# CRANE National Vendors

## SERVICE BULLETIN

**B4859901**

**Refreshmentcenter Hot Water Tank Revision**

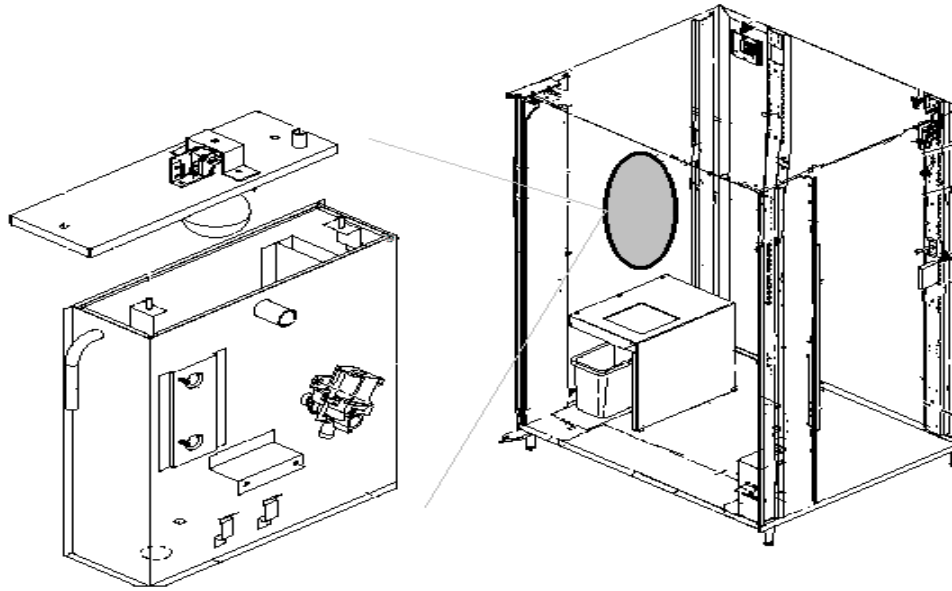
The hot water tank has been redesigned in order to improve product reliability and overall merchandiser efficiency, the new part number is 485-8019.

This new tank will closely resemble the hot water tank we presently use on the Cafe System 7 and the Hot Drink Center and will have the following changes.

- a) The water valve and bracket assembly now utilized on this merchandiser is part number 623-8112, the older valve assembly part number 475-1256 will **NOT** fit the newer tank.
- b) In order to reduce the possibility of leaks the utility hose is now fastened to a welded nipple at the base of the tank with a hose clamp rather than through a threaded fitting.

Please keep these changes in mind when replacing the older hot water tank with the newer hot water tank assembly.
